PROJECT
Proposed window / entrance atrium to front elevation, single storey flat roof rear extension to include removal of rear pitched roof, garden room and boundary wall to front of dwelling

DETAILS
Existing & proposed elevations

DRWG No. 418/1/2015^A

^A Proposed Rear Elevation

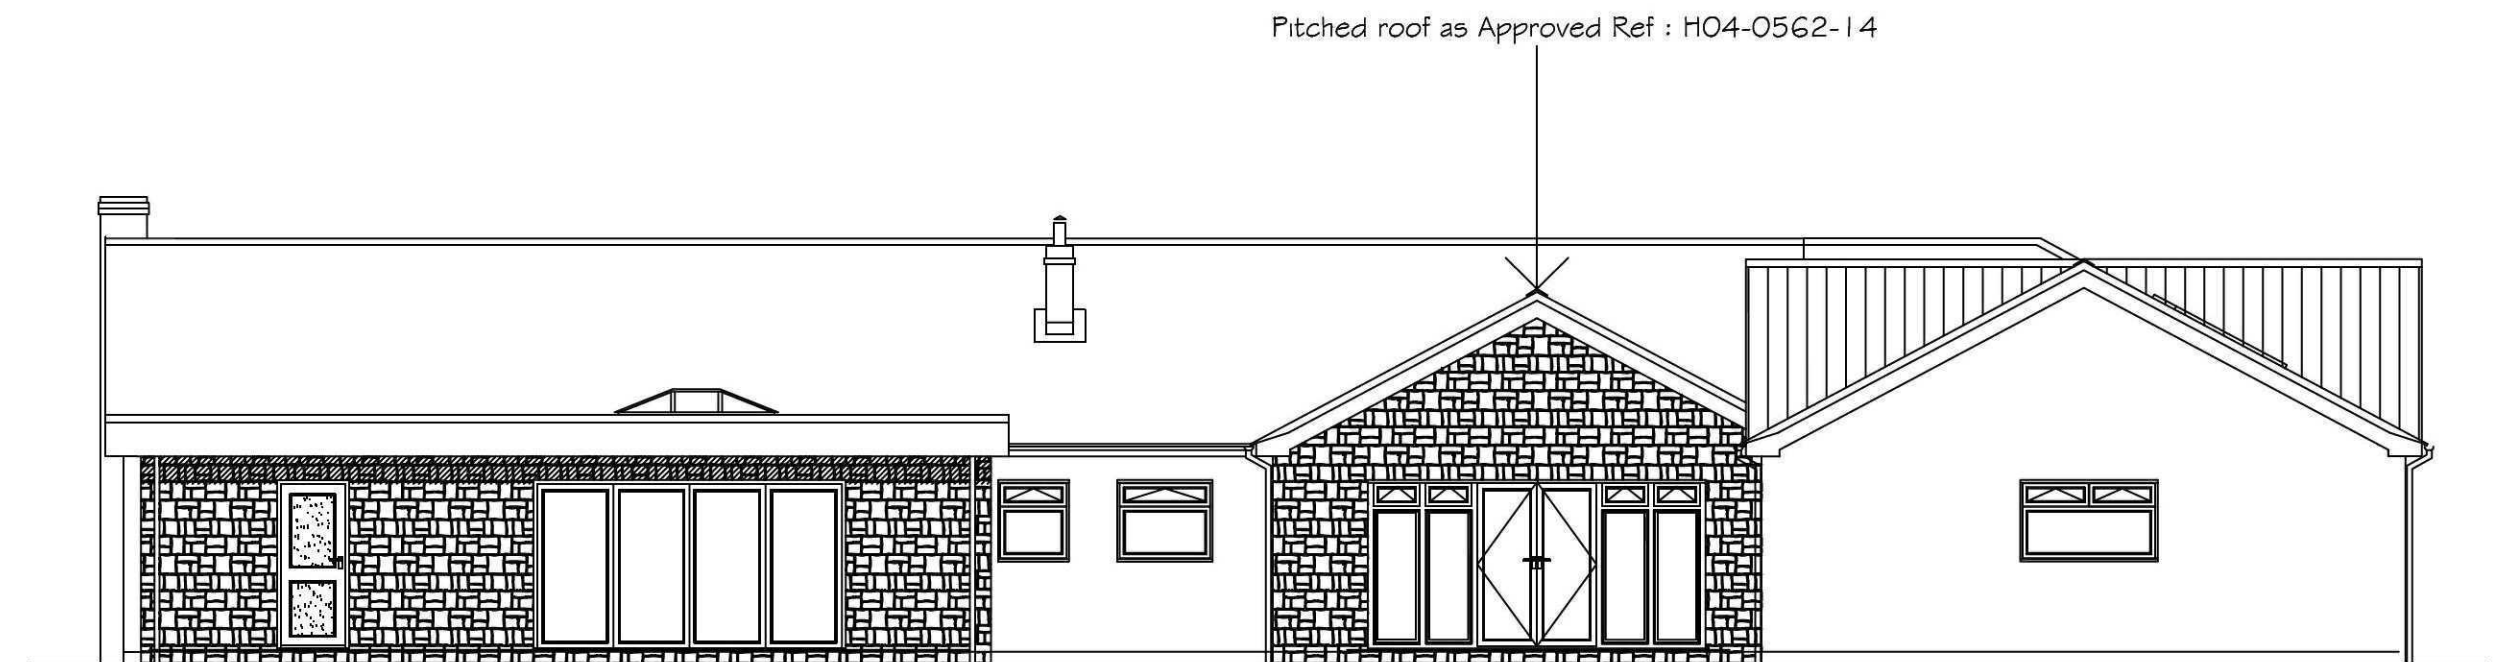
A Rear flat roof revised to include pitched as Approved on H14-0562-14
mjlw 18/3/15

Pitched roof as Approved Ref : H04-0562-14
Roof lantern size shown :
Kitchen : 1500mm wide x 2000mm long
Above size subject to clients confirmation prior to ordering
